# Memorandum to the City of Markham Committee of Adjustment

**File:** A/076/22  
**Address:** 4 James Glover Drive, Markham  
**Applicant:** Nimal Nadarajah  
**Agent:** Nimal Nadarajah  
**Hearing Date:** Wednesday September 21, 2022

The following comments are provided on behalf of the West Team. The applicant is requesting relief from the following requirements of “Residential Two\* 456 (R2\*456)” zone under By-law 177-96, as amended, as it relates to a proposed secondary dwelling unit in the basement. The variances requested are to permit:

PROPOSED SITE PLAN

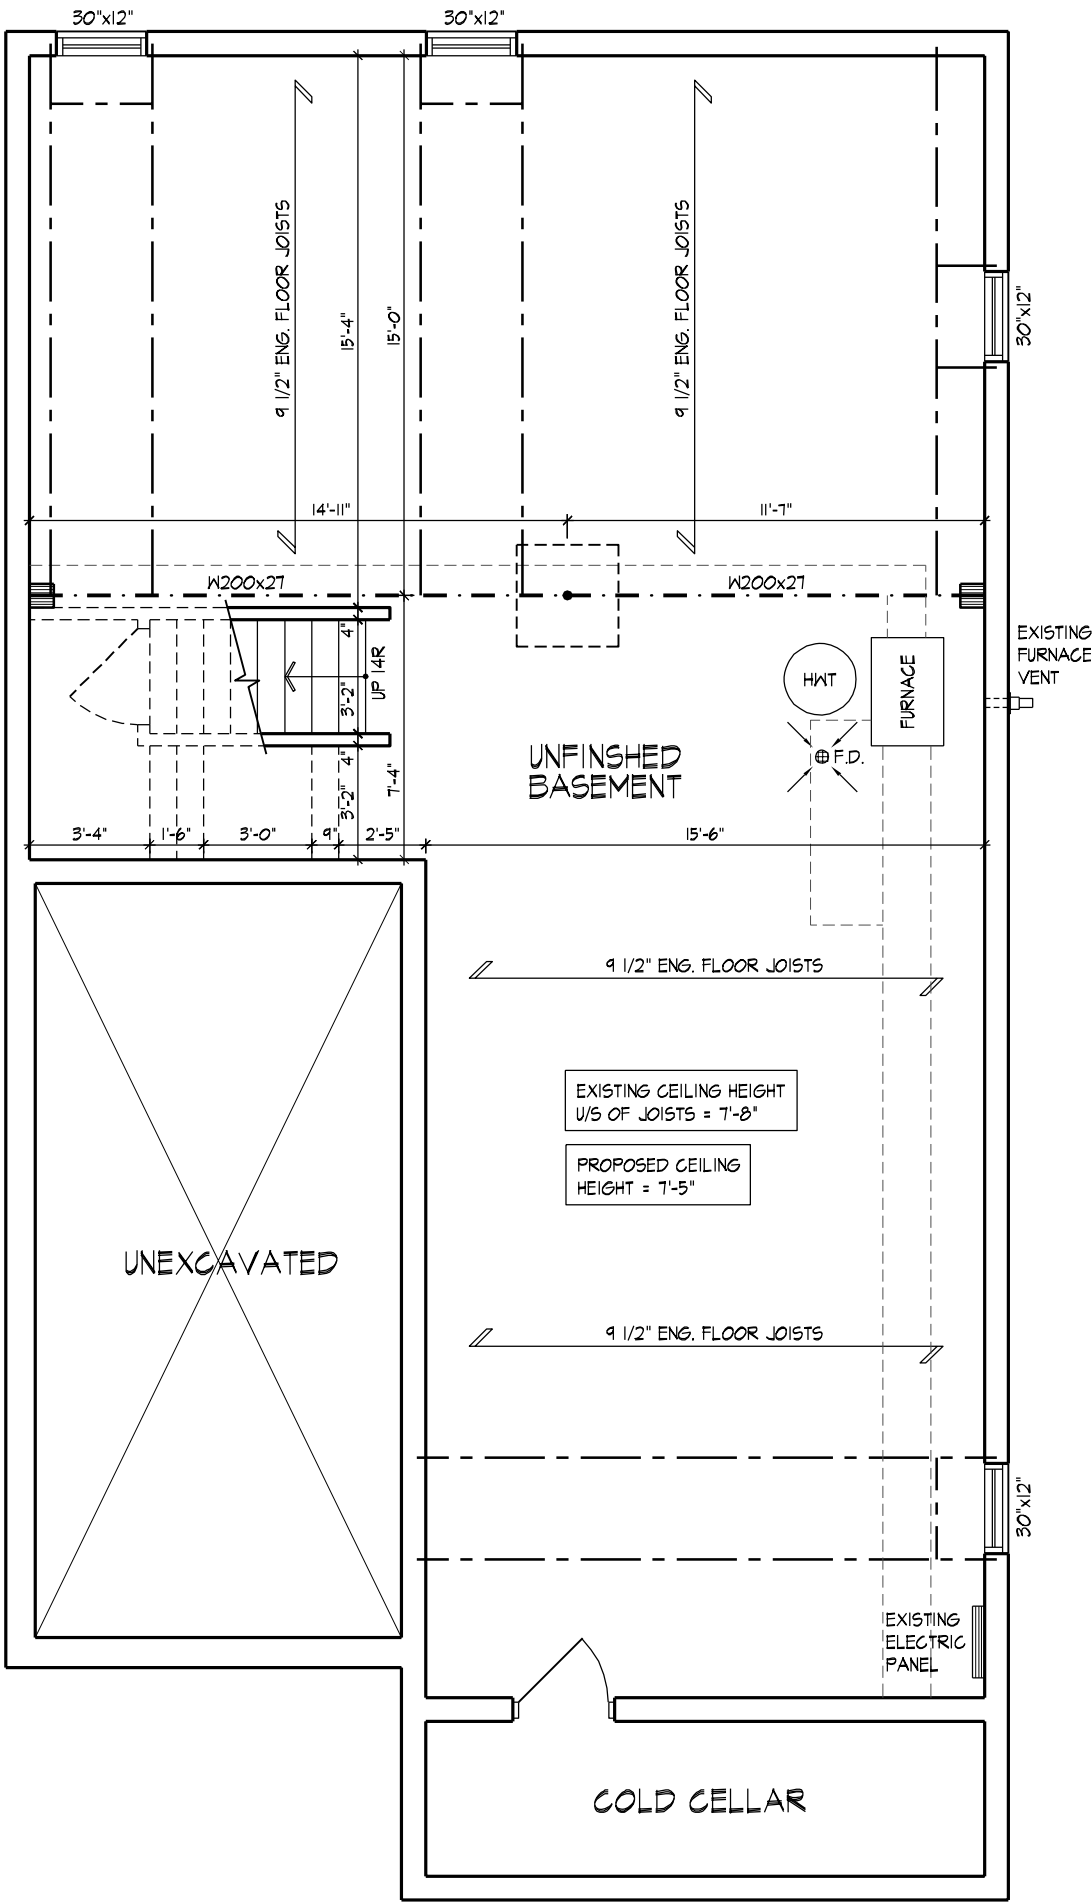
Staff note that the driveway currently has a width of 8.49m (27.85ft) whereas the By-law permits a maximum driveway width of 4.67m (15.32ft). The proposed variance will result in a loss of soft landscaping area which will detract from the visual appearance of the neighbourhood. In addition, the increase in hard surfaces will reduce the opportunity for storm water to infiltrate into the ground thereby increasing water runoff into the storm sewer system. Staff are of the opinion that the requested variance will compromise the existing character of the community.

Planning Staff have reviewed the application with respect to Section 45(1) of The Planning Act, R.S.O. 1990, c. P.13, as amended, and are of the opinion that requested variances A and B with respect to the accessory apartment and parking reduction meets the four tests of the Planning Act and have no objection. Requested variance C with respect to the driveway width variance does not meet the four tests of the Planning Act and recommend the variance be denied. Staff recommend that the Committee consider public input in reaching a decision.
